TECHNICAL MEMORANDUM

April 10, 2025
File No. 0202349-002

SUBJECT: Former Gun Club Cleanup Action

REPOSITORY FINAL
GRADING PLAN

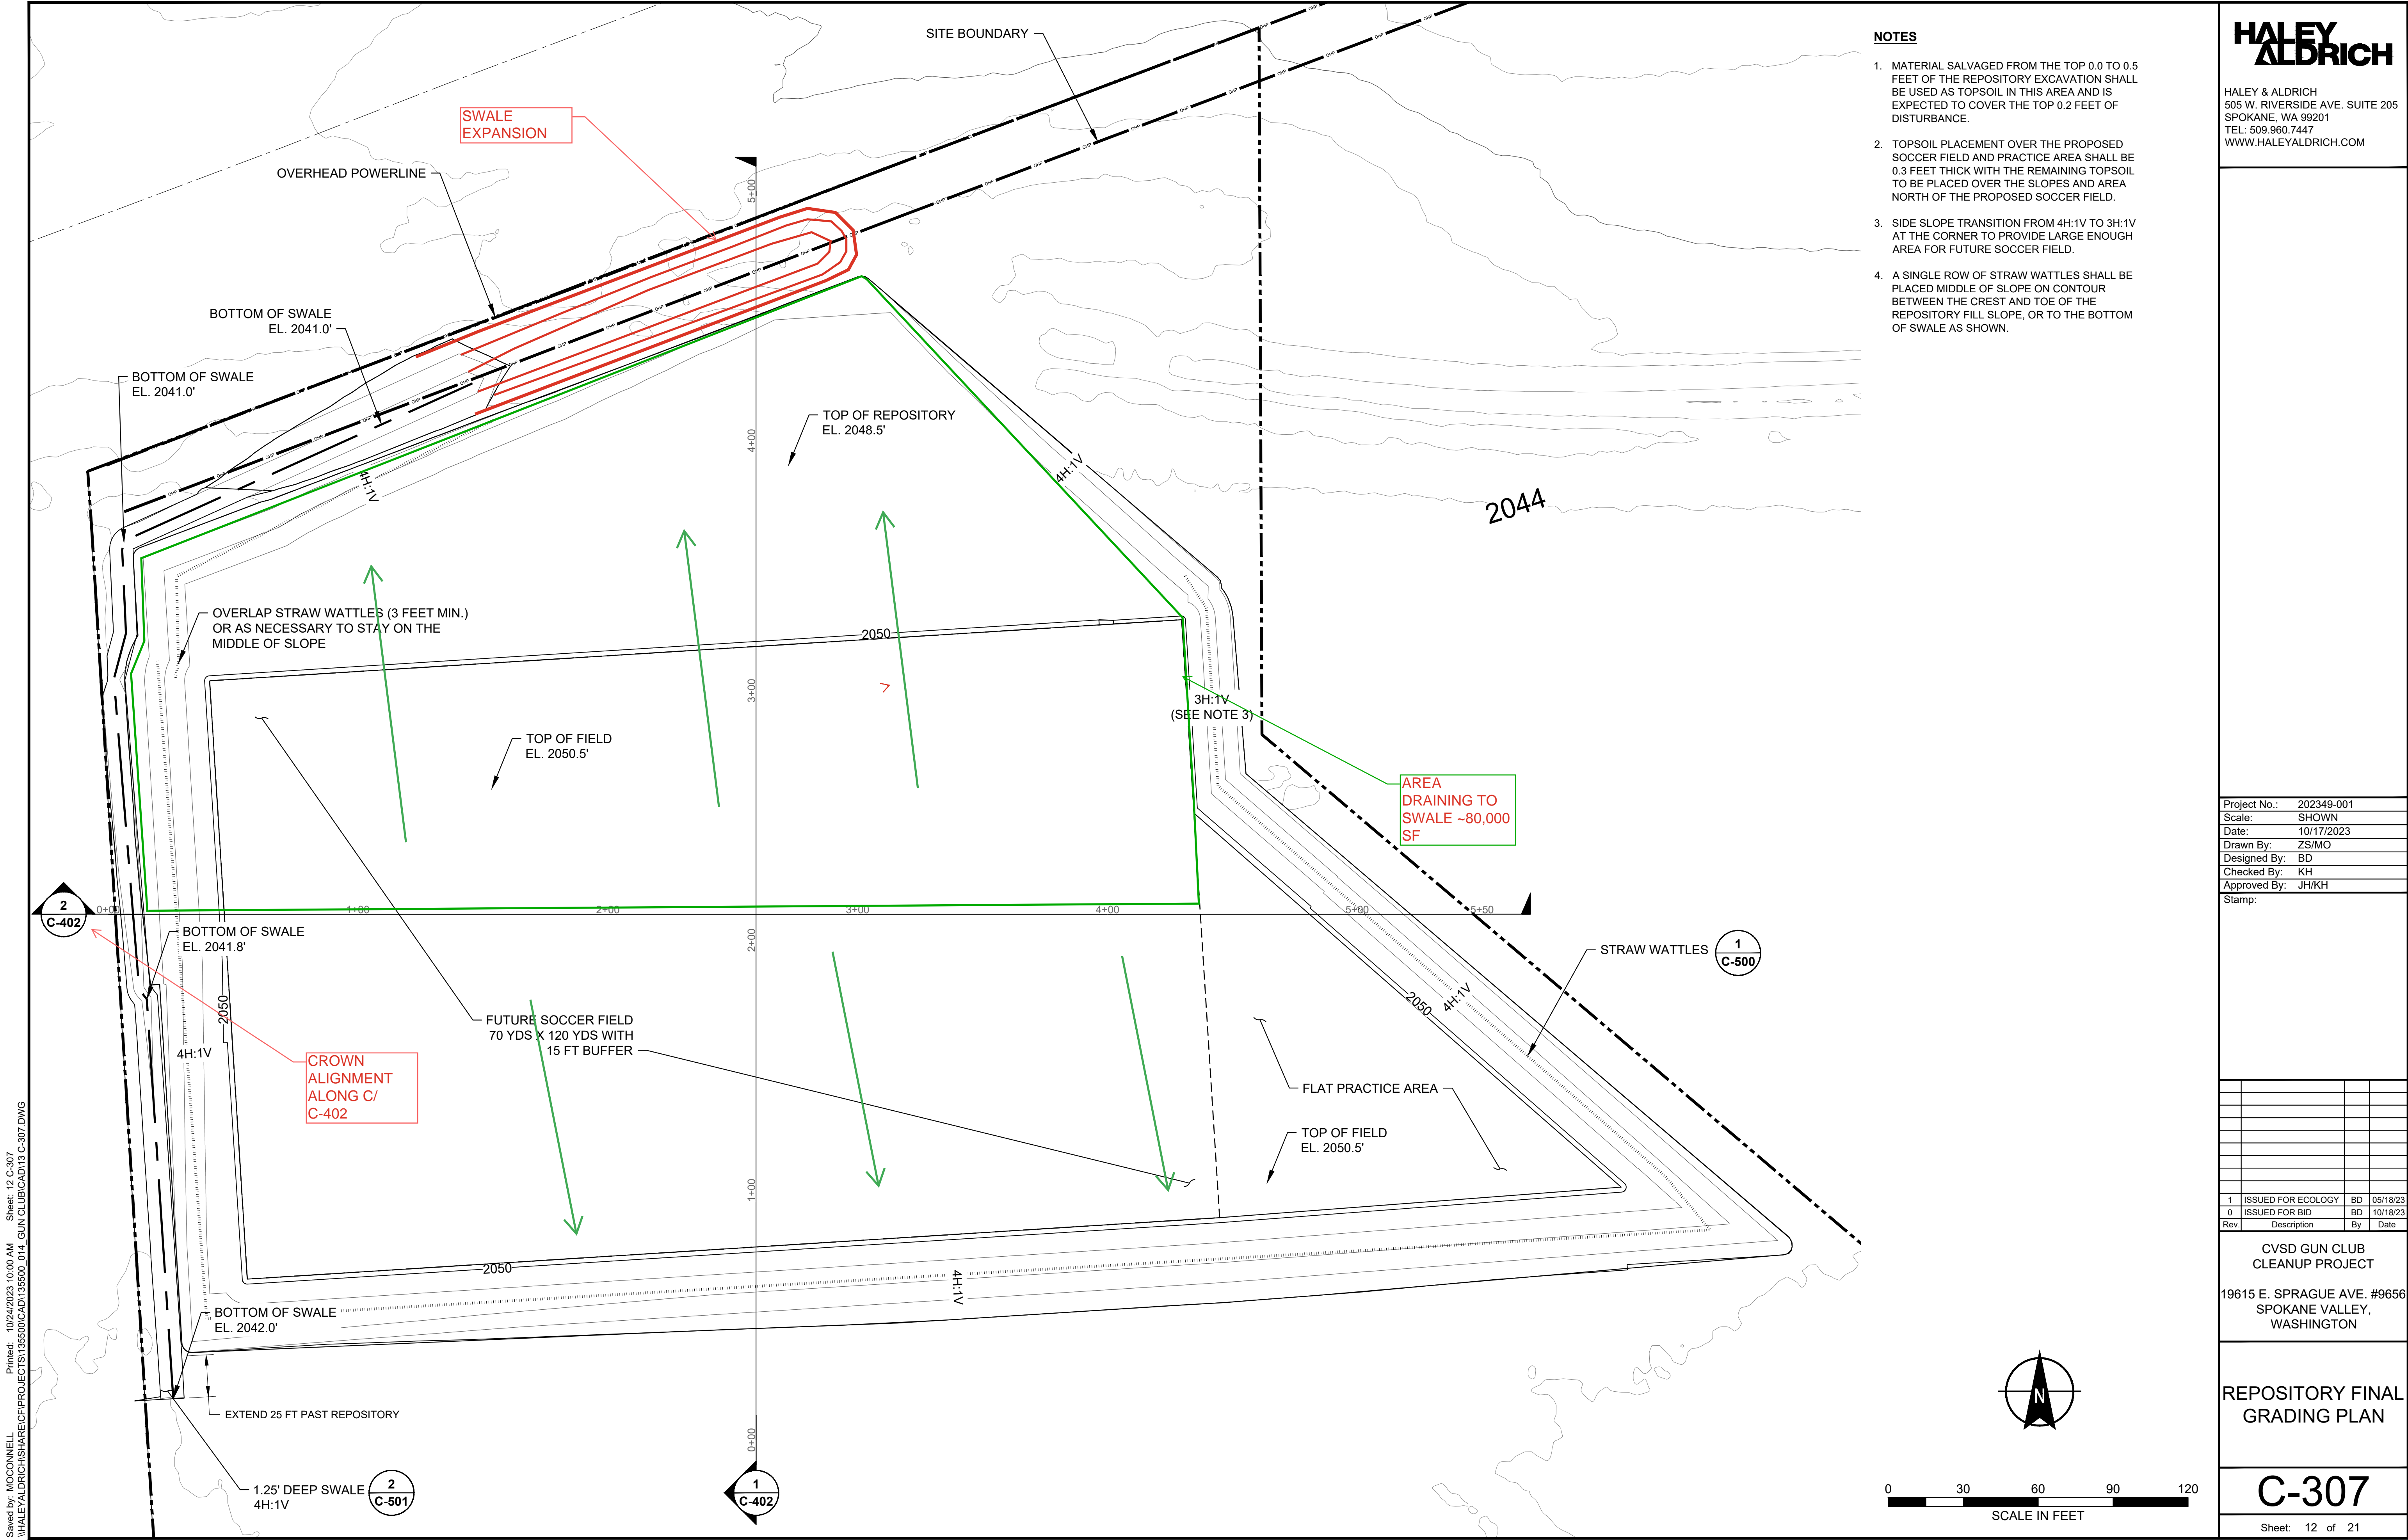
2. **City Comment:** I am concerned that there is no discharge for the composite drainage net. Typically, subsurface drainage systems have a pipe and discharge to a disposal location (drywell, infiltration trench, etc.). Based on the relatively shallow geomembrane and the lack of discharge, the cover soil will likely become completely saturated at times from irrigation, snow melt, and rain. This could essentially create an impermeable surface that will create stormwater runoff. The current plans only have a small swale on the west and northwest portions of the repository. My concern is that runoff from the other sides of the repository does not have a safe disposal area. Based on the Spokane Regional Stormwater Manual, could you please provide drainage calcs to show that water from a 10-year storm event will be contained, and that water from a 100-year storm event will have a safe overflow path (at minimum)?

Haley & Aldrich Reply: *A hydrologic analysis of stormwater flow was conducted under the Spokane Regional Stormwater Manual¹ in response to this comment. The hydrologic analysis was completed for the northern portion of the repository (approximately 80,000 square feet) that drains to the north from the repository crown along alignment 2 shown on the Repository Final Grading Plan, Attachment A. The southern portion of the repository flows freely onto CVSD-owned property and is not at risk of leaving the site.*

The SRSW specifies the Natural Resource Conservation Service (NRCS) Type 1A 24-hour design storm with the retention of runoff from the 10-year storm and safe conveyance of runoff from the 100-year storm. We modeled the runoff volume generated using the Curve Number Method in Hydraulic Modeling Software (HMS; Version 4.12) for a variety of potentially applicable curve numbers (74 = U.S. Department of Agriculture [USDA] Soil Type C grass, and 100 = smooth HDPE liner surface); see Attachment B. Conservative curve number 100 was ultimately utilized for design; curve number 100 translates precipitation directly to runoff and HMS modeling was not required. To retain the 10-year storm (395 cubic yards; Attachment C) in the infiltration swale, the swale was expanded along the north side of the repository, between the repository and the northern property line (see Attachment A). The expanded swale will retain greater than 400 cubic yards of stormwater. Safe conveyance of the 100-year storm (modeled at 553 cubic yards) will occur via overland flow in the vicinity.
